## CLARIFICATION OF ADDITIONAL INFORMATION

**SD22A/0081**

Kingswood Farm, Moneenalion Common Lower, Kingswood, Dublin 22

Clondalkin Rugby Football Club Ltd

Fig. 4.1 PROPOSED CYCLE TRACK ACCESS OFF R136:

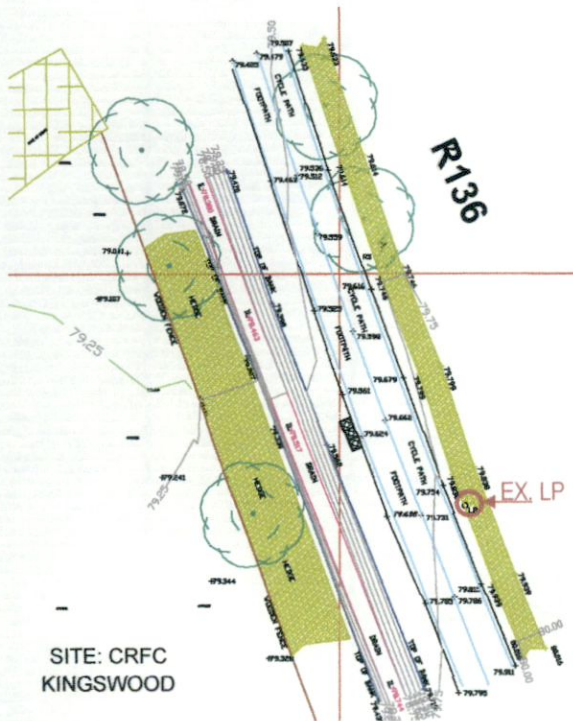
- (d) There is no mention of the existing lighting provision on the R136. The applicant is requested to clarify if the new entrances onto the R136 will require any relocation of existing poles or tie ins to supplies for additional poles to lighting the new section of Cycleways.

Regarding the existing Public Street Lighting along the R136 we did note in our AI response the following:

*“Regarding Public Lighting the additional areas surveyed picked up the positions of the existing Public Lighting Poles (LP) present within the extent of the areas surveyed along the R136. With reference to these surveys in Appendix B we have deliberately made use of this already existing public infrastructure by positioning each Stair and Cycle Track entrance position close to these existing LP positions. This strategy will avoid the need for additional lighting on the R136 side while at the same time it minimises any potential disruption to existing Public Lighting services.”*

Refer to Appendix B in our response to AI Request, dated 31<sup>st</sup> August 2022, which includes scale 1:200 snips (on the A4 page) for the additional survey detail gathered in these locations and where we highlighted existing LP locations. These survey snips are reproduced here for convenience, albeit not to scale here:

The intent was to take advantage of the existing public lighting infrastructure for both new entrances off the R136 and thereby avoid any impact on the existing Public Lighting services here while, at the same time, avoiding any unnecessary additional costs for all concerned in the pursuit of good sustainable development.

**Fig.5: Lux level survey  
Along R136 Cycle Track & Footpath  
(~6am on 29.11.2022)**

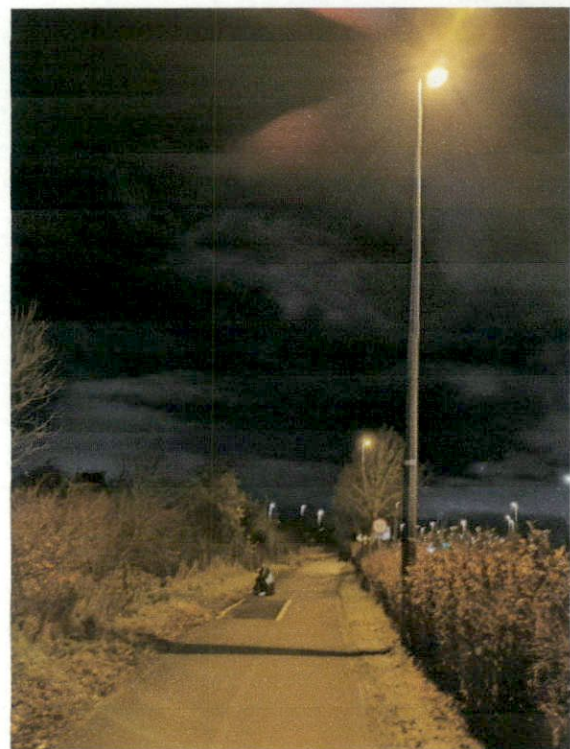
- (e) The existing lighting along the access routes to the new entrance to the clubhouse and carpark is sporadic and insufficient to adequately light the additional traffic associated with the new development. The applicant is therefore requested to liaise with SDCC Public Lighting and Public Realm Section regarding consideration for an appropriate upgrade of the street lighting provision along the roads accessing the new development that will not have a significant adverse impact on bat species.

All lighting works on site will be carried out in accordance with the SDCC's Public Lighting Specification and Standard Details where applicable.
